825 NORTH BROADWAY WHITE PLAINS, NY 10603 (TOWN OF NORTH CASTLE)

AUTOMOBILE SERVICE STATION ALTERATION (GAS TANKS REPAIR AND CONVENIENCE STORE INTERIOR ALTERATIONS)

We have revised the plans to answer the May 20, 2022 comments from the Town Consulting Engineering John Kellard, P.E. as follows (**in bold**):

LANDSCAPING PLAN
SCALE: 1" = 10.0'

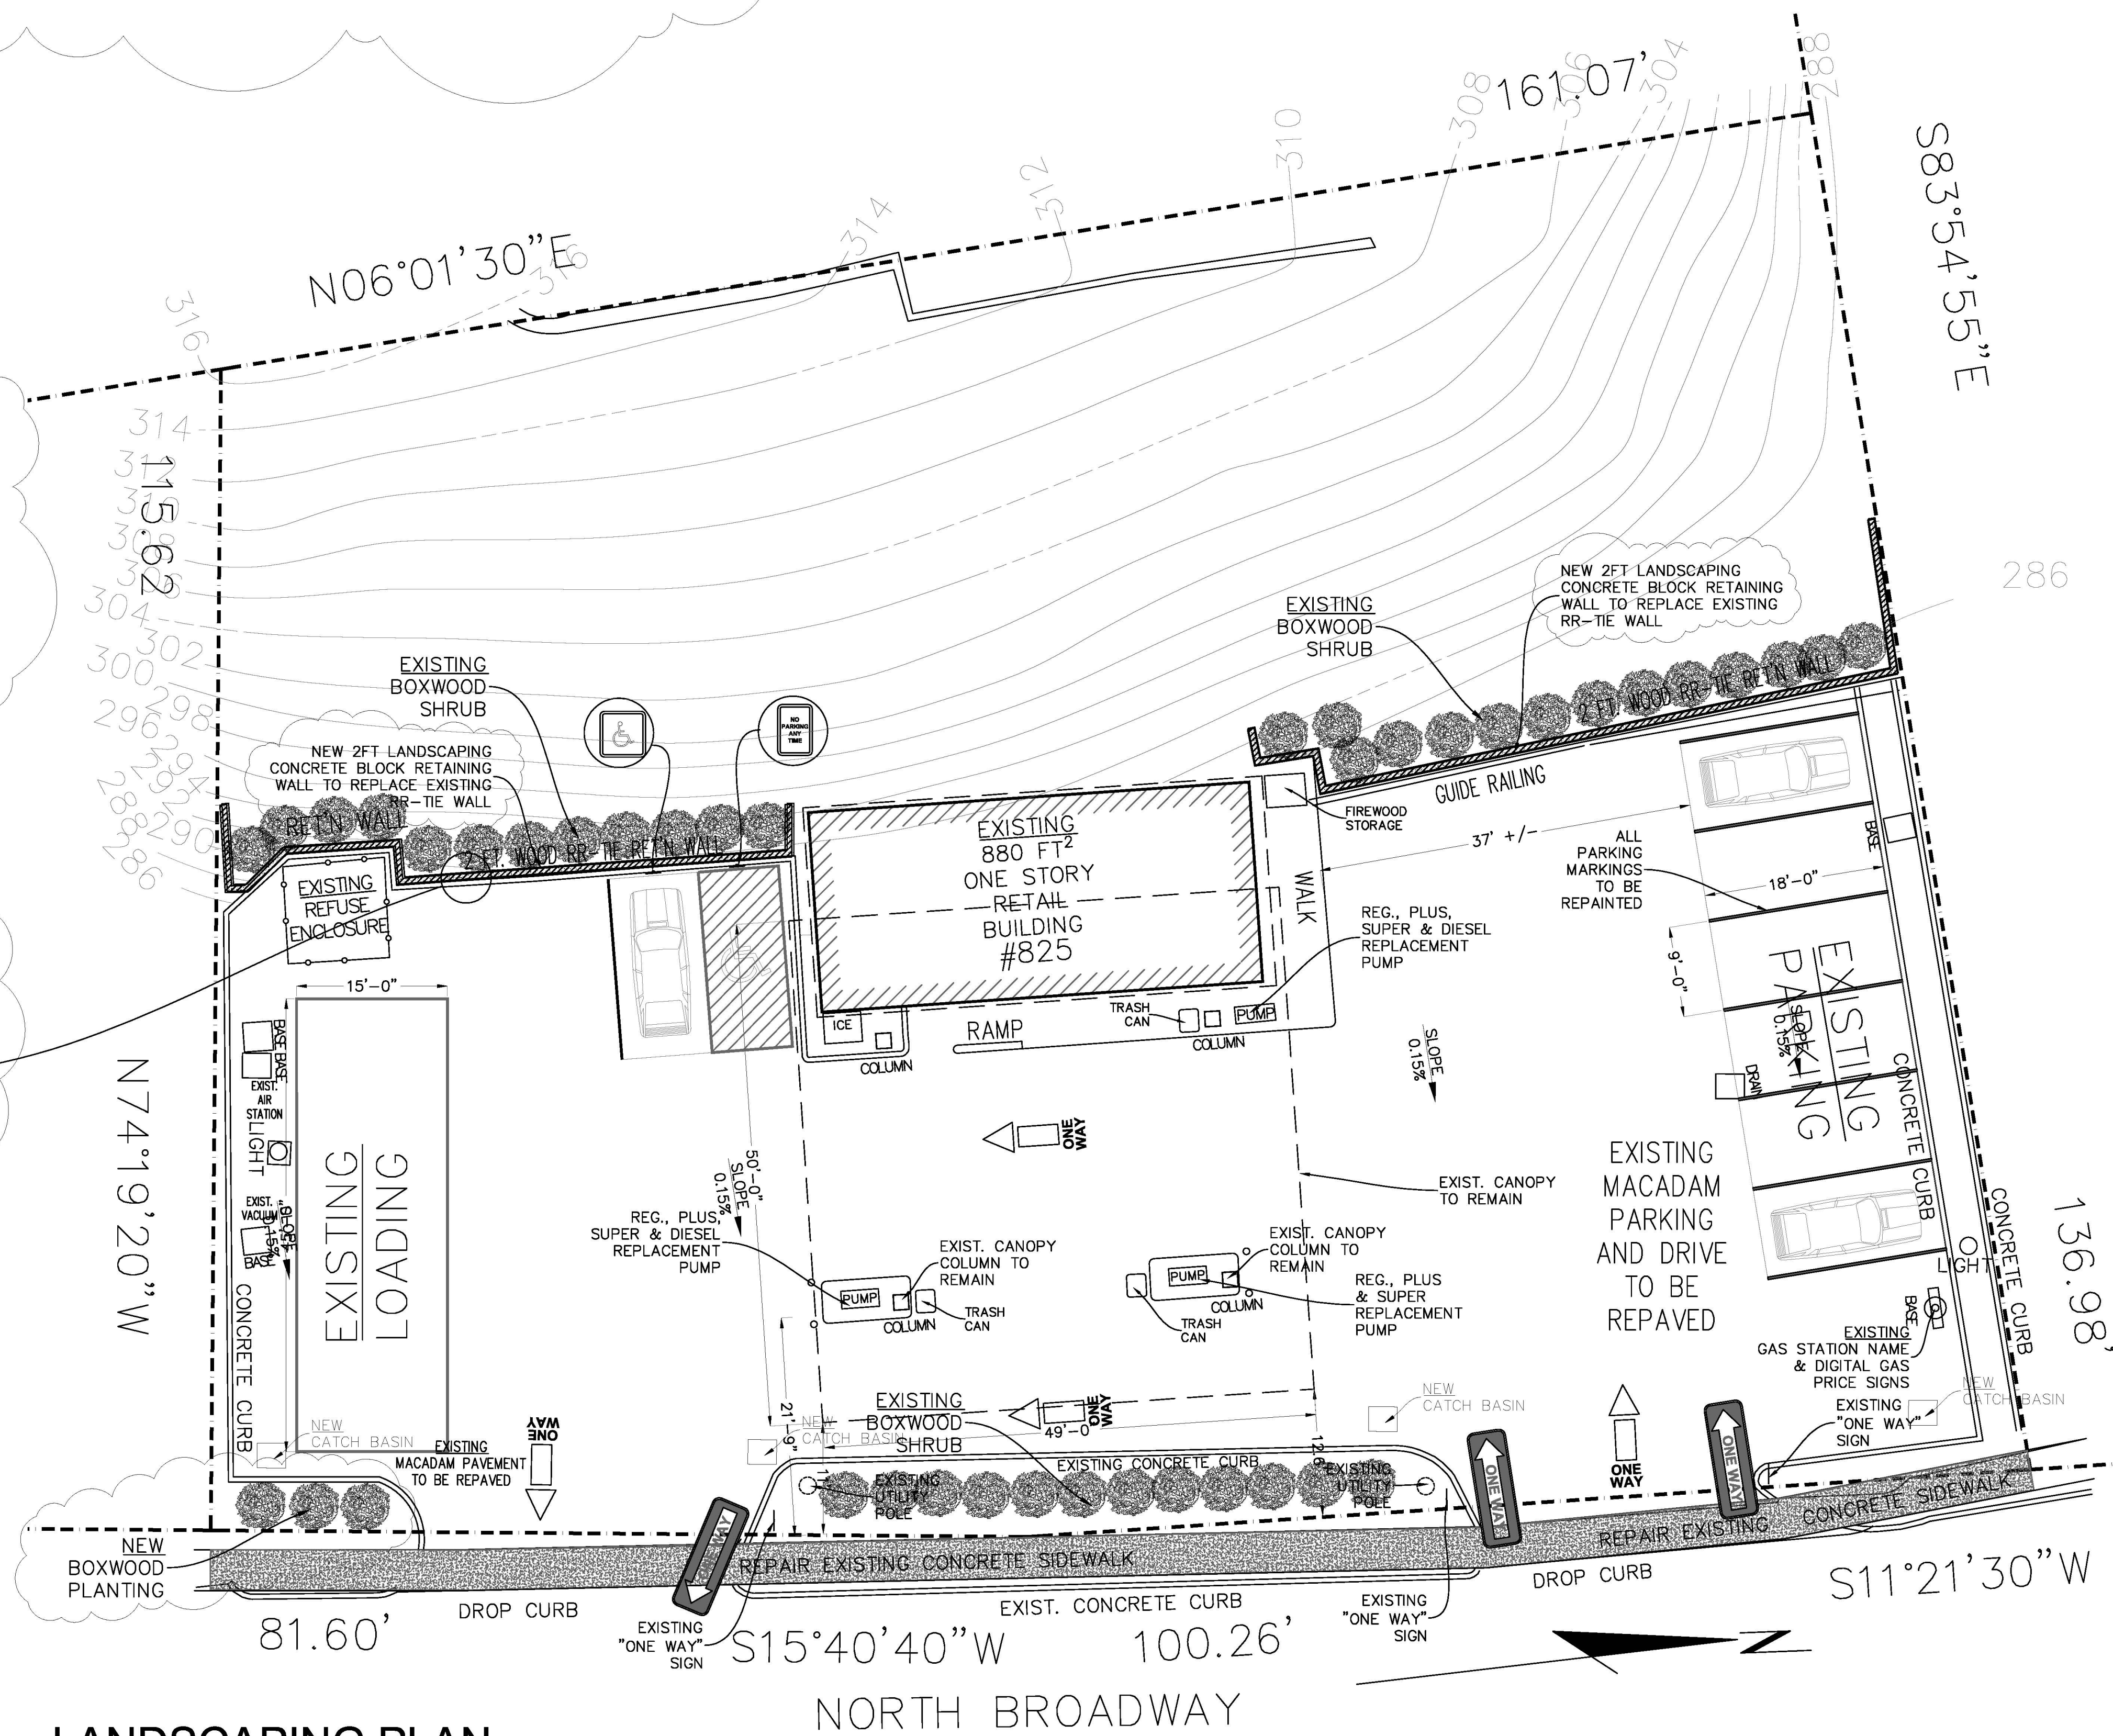
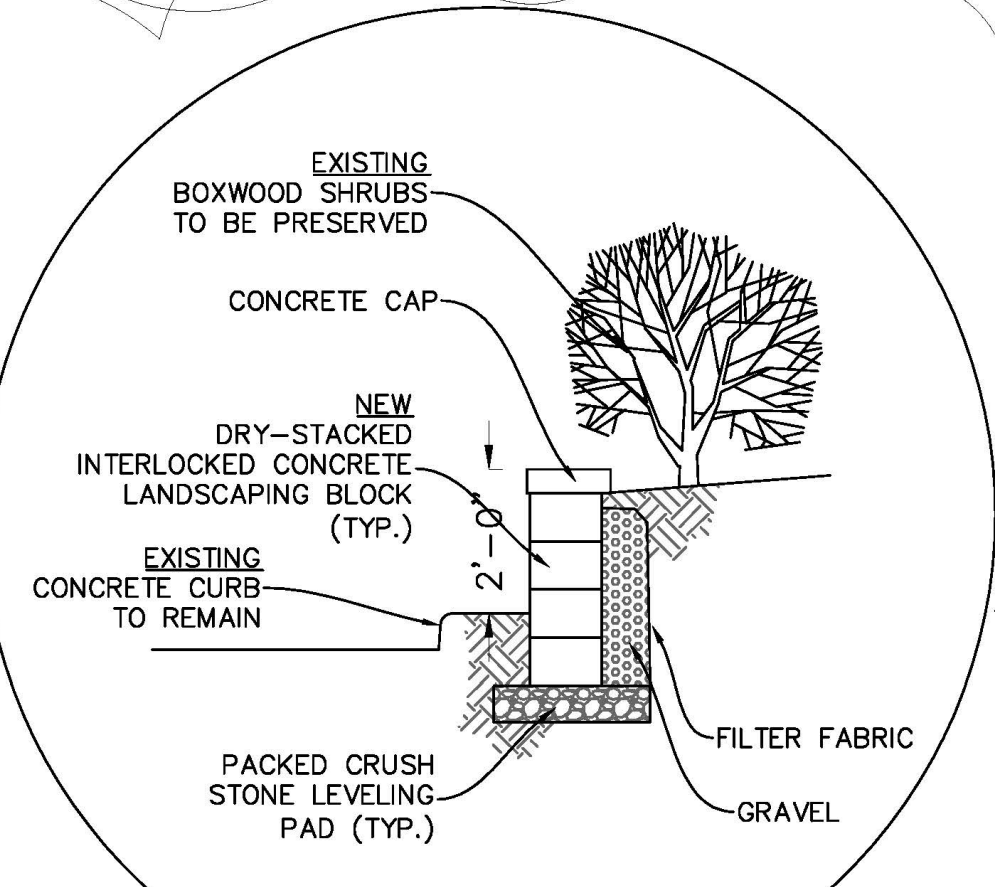
5. Please provide construction details of all proposed site improvements.

6. The applicant's landscape improvements include three (3) arborvitae along the southern property frontage. The arborvitae are noted to grow to a height of 40 feet and a width of 8 – 20 feet. This may not be the appropriate plant for that location. The Landscape Plan Sheet L1 shows existing boxwood shrubs along the center island frontage and above the retaining wall within the rear of the property. It appears that the existing boxwood along the frontage and in the rear behind the refuse enclosure need to be replaced. The Planning Board may wish at this time to review the site landscaping in more detail and determine whether landscaping along the property frontage and along the neighboring properties is adequate. There appears to be opportunities to reduce the hardscape and introduce additional landscaping along the property frontage within the northeast corner of the site, southeast corner and southern property boundary.

I am calling out the 2FT RR-Tie retaining walls to be replaced with " 2FT landscaping concrete block retaining walls", and added a section detail on page L1.

Arborvitae replaced with Boxwood to match existing. Planting scheduled revised. Note added to indicate existing boxwood plants behind the RR-tie wall to be removed, stored and re-planted or replaced.
